Access Compliance Report Public Rights-of-Way (Pedestrian Signals)

Main Street: **BROWNING_AVE** Cross Street: **IRVINE_BLVD** Location: **NW**

ADA ID: **SGRK211006111902** Signal Type: **One Push Button-APS** Overall Compliance: **No** Severity Scores: **BTN 1: 25** **BTN 2: N/A** **No BTN: N/A**

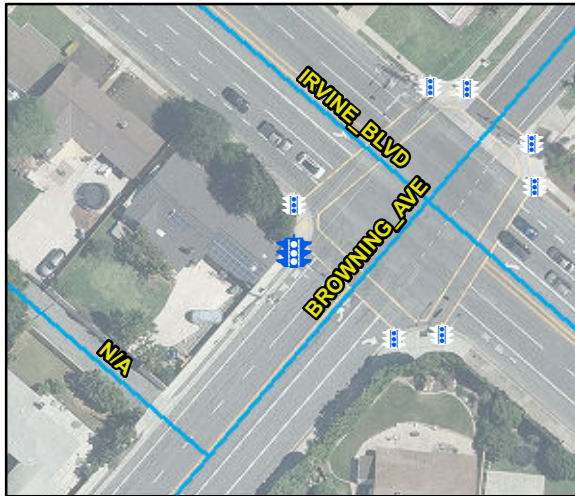
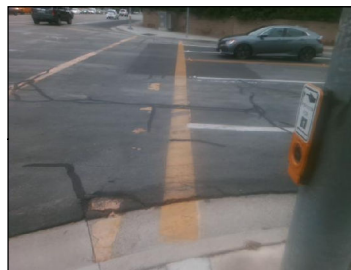
OC Std/PROW: **R404.2**

Possible Solutions: Remove and Replace Clear Space.
